CAP INSPECTION REPORT

Site: <u>The Fields Neighborhood Park</u> Inspection Date: <u>10/25/2019</u>

NW 11th, NW Overton, and NW Naito (1N1E 34BB Lot 2629)

Photo 6: Surficial crack in concrete

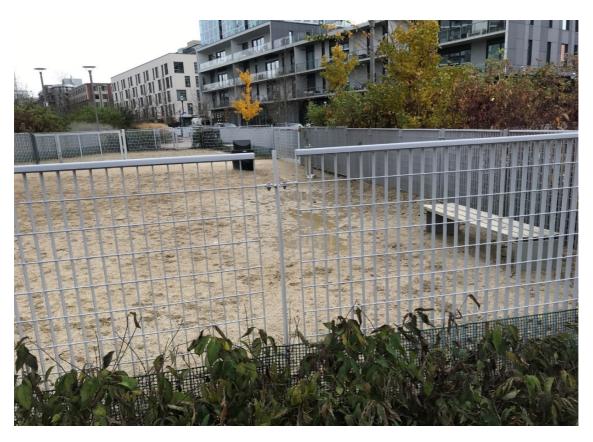
Location: <u>Various locations</u> within the hardscaped areas (concrete, asphalt, bricks). <u>Minor cracks</u> were observed (generally less than 0.5 inches) that do not appear to penetrate the cap. <u>One brick pathway is slightly separating</u>. <u>Damage does not appear to penetrate the cap.</u> (see attached photos)
